# UNITED STATES PATENT AND TRADEMARK OFFICE

APPLICATION NO.	FILING DATE	FIRST NAMED INVENTOR	ATTORNEY DOCKET NO.	CONFIRMATION NO.
10/680,490	10/08/2003	Pieter Vorenkamp	1875.3610001	5497

<b>Office Action Summary</b>	<b>Application No.</b>	<b>Applicant(s)</b>
	10/680,490	VORENKAMP ET AL.
	<b>Examiner</b> Betsy L. Deppe	<b>Art Unit</b> 2611

FIG. 1

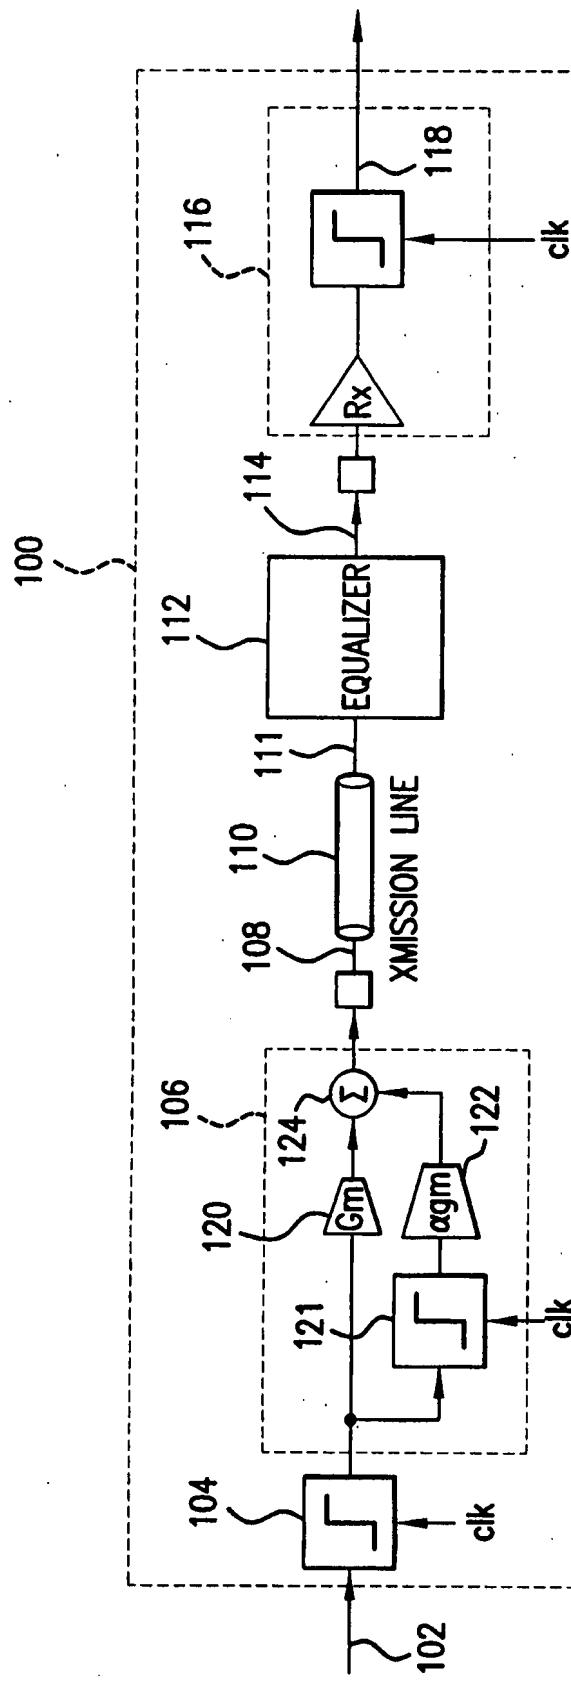
Acceptable  
B. Deppe  
9/6/07
